Ogdensburg City School District

2023 Capital Outlay Project

Catch Basin Rehab

CHANGE ORDER CERTIFICATION

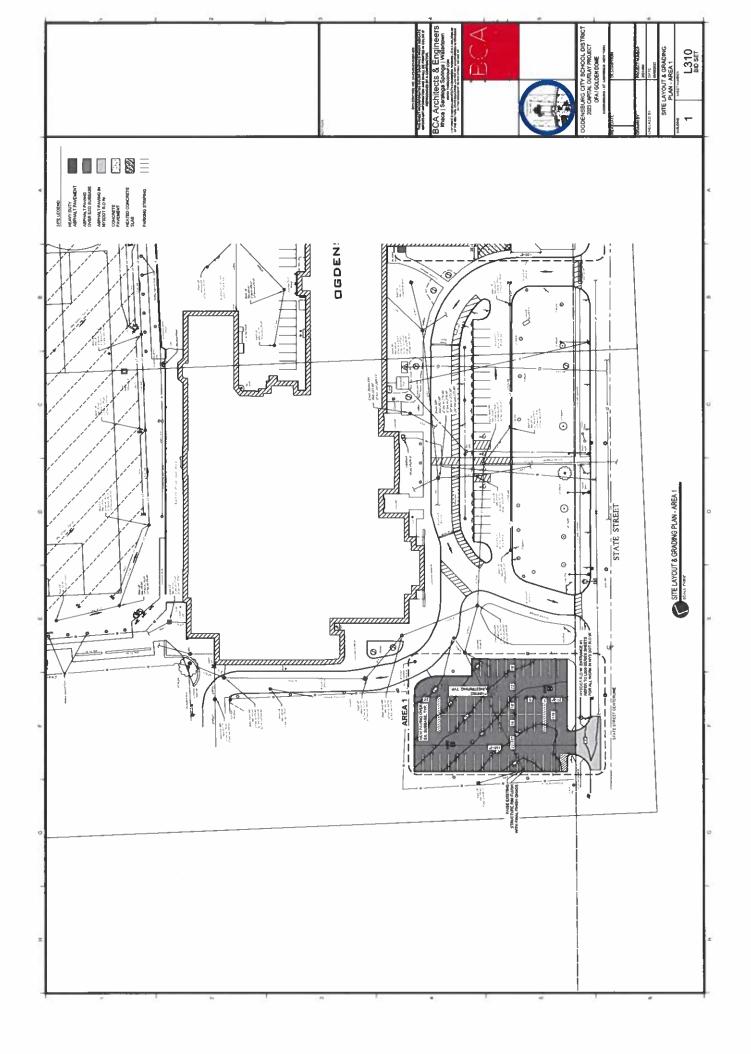
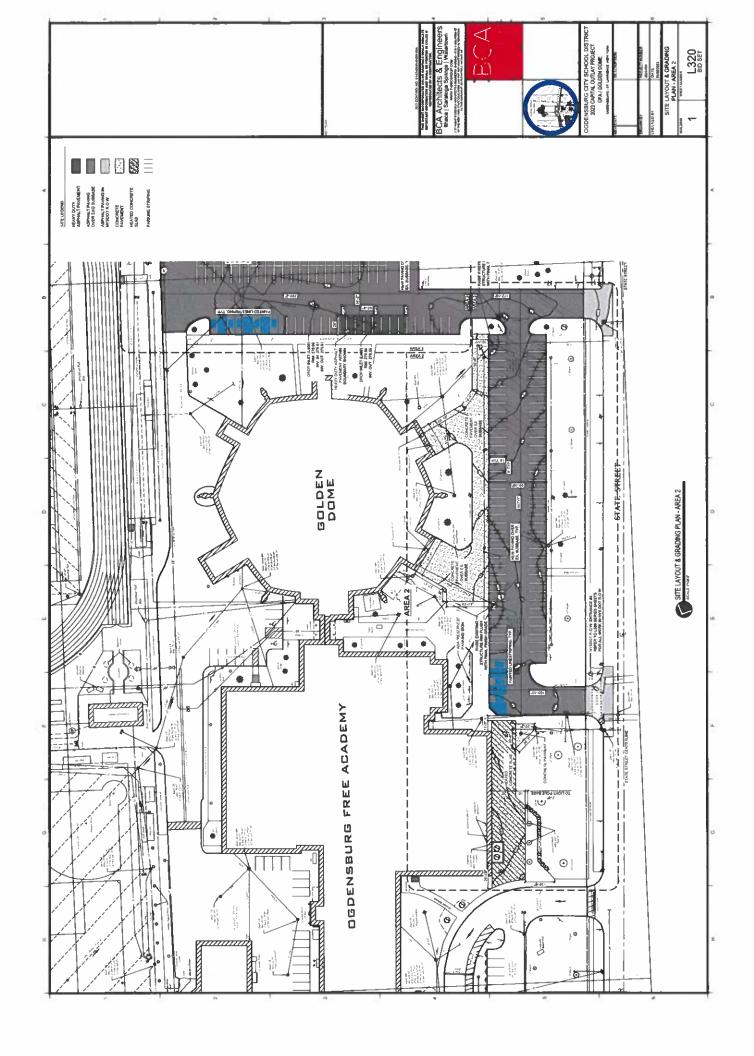
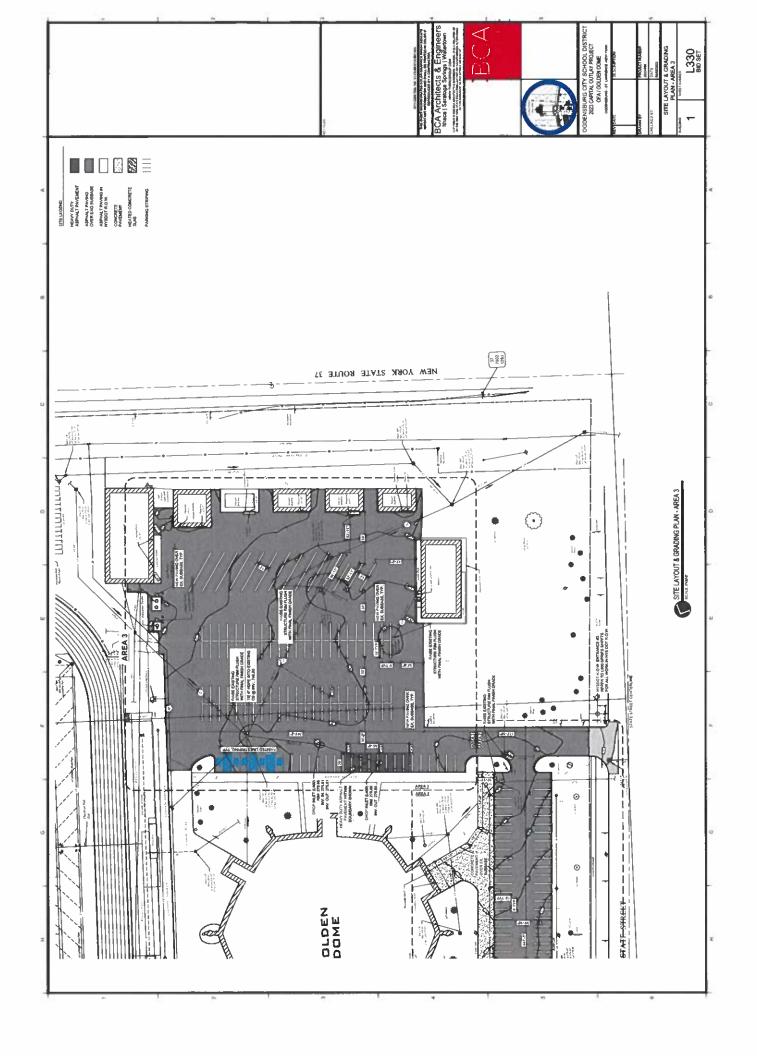
Option 1: Provide all labor, material, and equipment to cut back existing asphalt binder and top to stable material in line and symmetrical with existing catch basin rim structure. Provide new asphalt binder and top within the removal footprint pitched to catch basin. Provide asphalt sealer at new joints. Recompact subbase as required.

Α	Owner
8	Under the Capital Outlay Project, existing catch basins / drop inlets were being adjusted in coordination with scheduled parking lot reconstruction as per Contract Drawing L310, L320 & L330.
С	During construction, the Owner requested that an additional catch basin / drop inlet be addressed since the General Contractor was already mobilized onsite. The catch basin was located in a pavement area outside the scheduled work zone and consisted of severely deteriorated asphalt around the immediate area that no longer allowed for proper stormwater control. To avoid further pavement deterioration, the Owner requested that the General Contractor cut back the asphalt and re-align the pavement with the catch basin rim structure.
D	Add to provide all labor, materials, and equipment to replace deteriorated asphalt around existing catch basin outside work zone limits and provide positive slope for proper stormwater drainage.
